**Verification and certification report form for  
CDM project activities  
(Version 04.0)**

<b>Title and UNFCCC reference number of the project activity</b>	Hydro Electric Plant - Hidro Pantasma UNFCCC ID: 9118		
<b>Scale of the project activity</b>	<input type="checkbox"/> Large-scale <input checked="" type="checkbox"/> Small-scale		
<b>Version number of the verification and certification report</b>	1.0		
<b>Completion date of the verification and certification report</b>	27/09/2021		
<b>Monitoring period number and duration of this monitoring period</b>	MP 1 <sup>st</sup> 07/10/2013 to 06/10/2020 (including both days)		
<b>Version number of the monitoring report to which this report applies</b>	2.0		
<b>Crediting period of the project activity corresponding to this monitoring period</b>	Fixed/Renewable Crediting Period 07/10/2013- to 06/10/2020 (including both days)		
<b>Project participants</b>	Hidropantasma S.A		
<b>Host Party</b>	Nicaragua		
<b>Applied methodologies and standardized baselines</b>	CDM Methodology: AMS-I.D. Version 17.0 - Grid connected renewable electricity generation Standardized baseline: N/A

“Hydro Electric Plant - Hidro Pantasma”

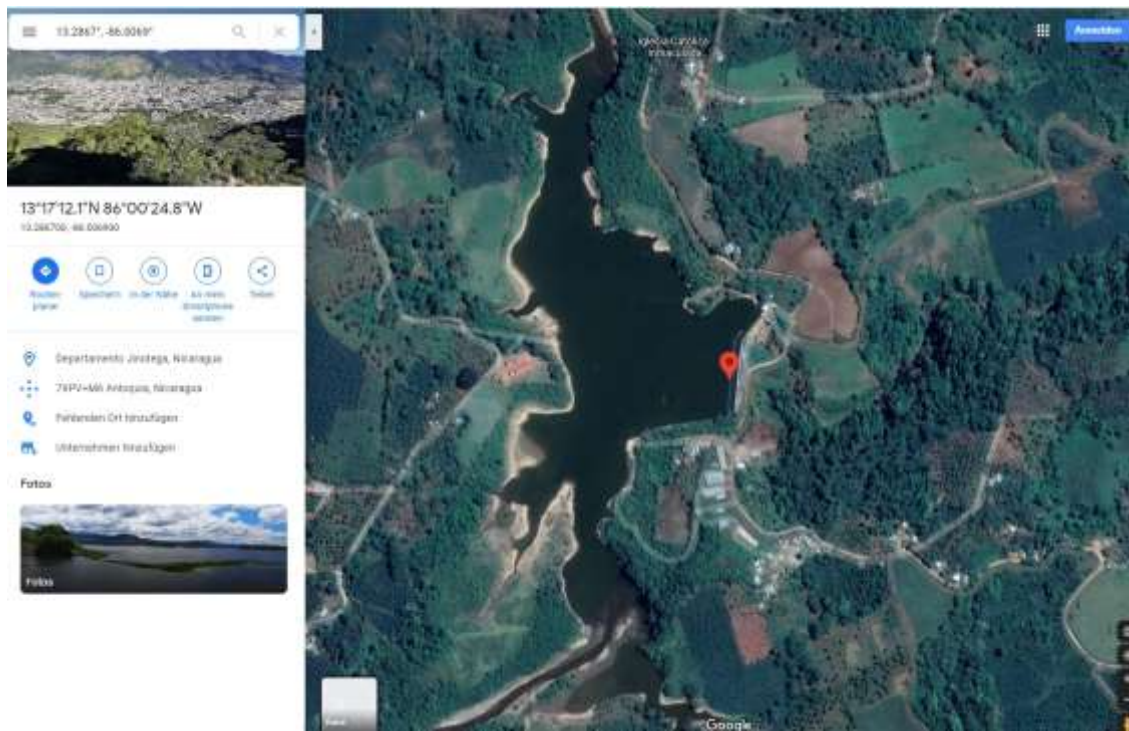
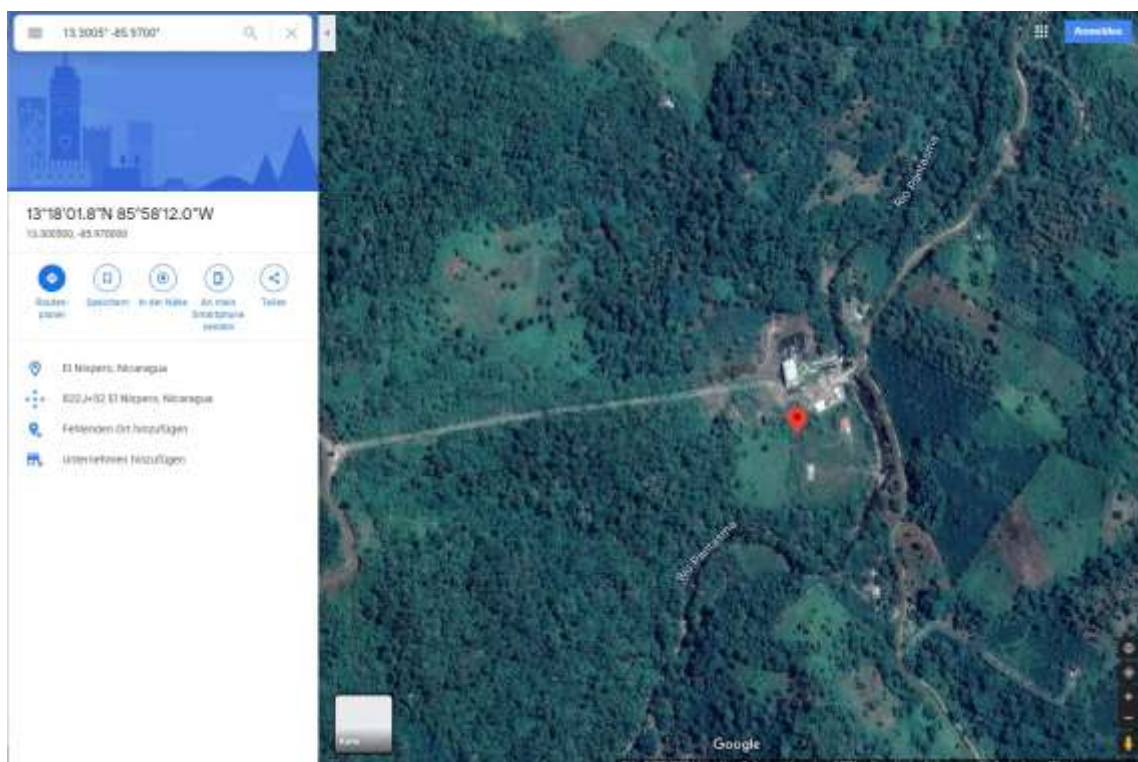
The location has been crosschecked with google maps as per following screenshots. To identify the related position the latitude and longitude values as per PDD section A.4.1.4. have been inserted in the search as indicated in the below screenshots at top left corner. CL1 has been raised and successfully closed..

CL ID	CL 01	Section no.	A.2	Date: 10/02/2021
<b>Description of CAR</b>				
Clarification on why the project location coordinates in the MR are slightly different than in the PDD				
<b>Project participant response</b>				<b>Date: 09/03/2021</b>
<i>This was a measurement error, so the coordinates were again updated according to the PDD, which correspond to the coordinates provided in the last “Social and Environmental Activities Implementation Report” of the project (Page 3).</i>				
<b>Documentation provided by project participant</b>				
210315_MR_Hidropantasma_TC.docx				
<b>DOE assessment</b>				<b>Date: 18/03/2021</b>
The reported coordinates are very similar to ones observed by the VT by google maps. The slight differences are due to the exact location of the GPS equipment, no major discrepancies are observed. Finding is closed
